Vision Apparels (PVT) Ltd. #9633

Plot # M-1/3, Section-14, Mirpur
(+23.803270N, 90.377548E)
05.MAY.2014

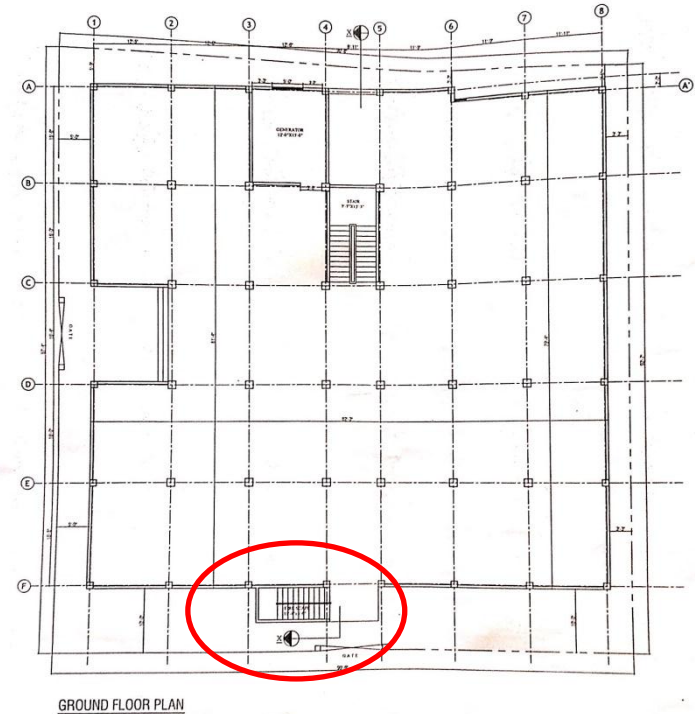
1st Priority 2 Concern

The emergency staircase on the side elevation of the 7 storey building is shown on the Architectural drawings, but is not shown on the structural drawings.

Item No.	Observation	Recommended Action Plan	Recommended Timeline
1	The emergency staircase on the side elevation of the 7 storey building is shown on the Architectural drawings, but is not shown on the structural drawings.	Detail Engineering Assessment is required for the emergency staircase.	6-weeks
2	The emergency staircase on the side elevation of the 7 storey building is shown on the Architectural drawings, but is not shown on the structural drawings.	Implement any works deemed necessary by the Detail Engineering Assessment.	6-months
3	The foundation depth shown on the structural drawings for the 7 storey building is shallower than specified in the geotechnical report.	Detail Engineering Assessment is required for the foundations of the 7 storey building.	6-weeks
4	The foundation depth shown on the structural drawings for the 7 storey building is shallower than specified in the geotechnical report.	Implement any works deemed necessary by the Detail Engineering Assessment.	6-months

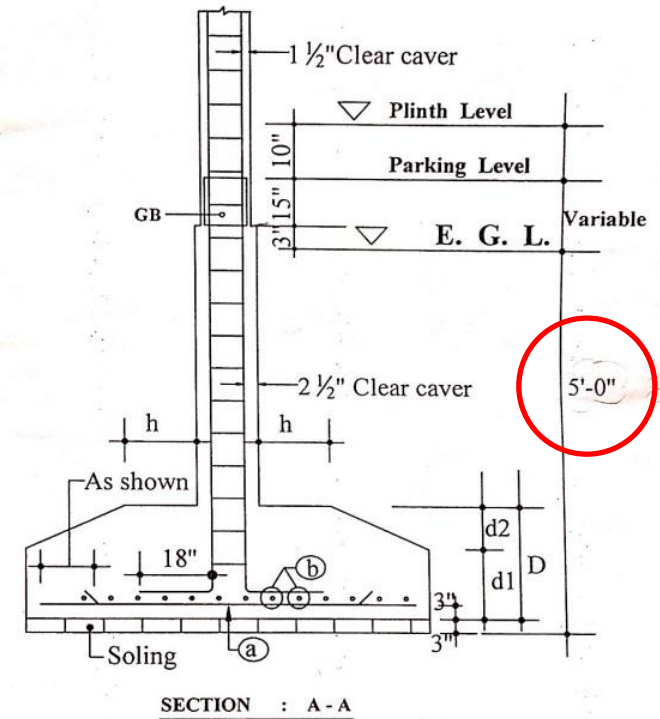
2nd Priority 2 Concern

The foundation depth shown on the structural drawings for the 7 storey building is shallower than specified in the geotechnical report.
